Access Compliance Report

Public Rights-of-Way

Intersection ID: 29422	Main Street: BRADSTREET_COMMONS_WY	Cross Street: SHINY_MEADOW_LN	Location: SW
ADA ID: F47CE5EC5EF1	Ramp Type: Perp	Initial Pass/Fail: Fail	Overall Compliance: No
Severity Score: 46.25			
Codes/Mitigation Info/Possible Solution		Field Measurements/Component Compliance

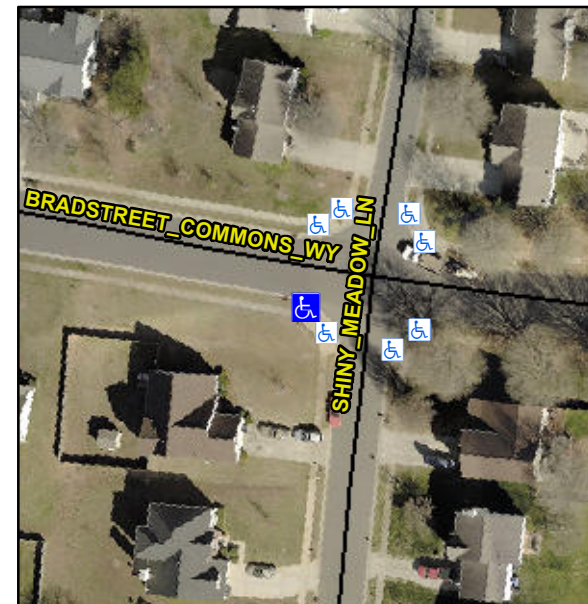
Not Found, R304.5.1, R304.2.2, R304.5.3

Compliance	Description	Data	Compliance	Description	Data
N/A	Ramp Length (in)	46.0	No	Ramp Slope (%)	13.9
No	Ramp Width (in)	42.0	No	Ramp XSlope (%)	6.3
N/A	Flare Type LT	N/A	N/A	Flare Type RT	N/A
N/A	Flare Slope LT (%)	N/A	N/A	Flare Slope RT (%)	N/A
N/A	Flare Traversable LT?	N/A	N/A	Flare Traversable RT?	N/A
N/A	Landing Length (in)	N/A	N/A	DWS Provided?	N/A
N/A	Landing Width (in)	N/A	N/A	DWS Contrast?	N/A
N/A	Landing Slope (%)	N/A	N/A	DWS Length (in)	N/A
N/A	Landing X Slope (%)	N/A	N/A	DWS Full Width?	N/A
N/A	Landing Curb? (Y/N)	N/A	N/A	DWS Offset (in)	N/A
N/A	Shared Landing?	N/A			
N/A	Gutter Ponding?	N/A	N/A	Gutter Slope (%)	N/A
N/A	Gutter Lip Ht (in)	N/A	N/A	Gutter X Slope (%)	N/A
N/A	Painted X Walk1?	No	N/A	Painted X Walk2?	N/A
	X Walk 1 Direction	To N		X Walk 2 Direction	N/A
N/A	X Walk 1 Width (in)	N/A	N/A	X Walk 2 Width (in)	N/A
	X Walk 1 Slope (%)	3.5		X Walk 2 Slope (%)	N/A
	X Walk 1 X Slope (%)	8.2		X Walk 2 X Slope (%)	N/A

Remove & Replace Entire Ramp.
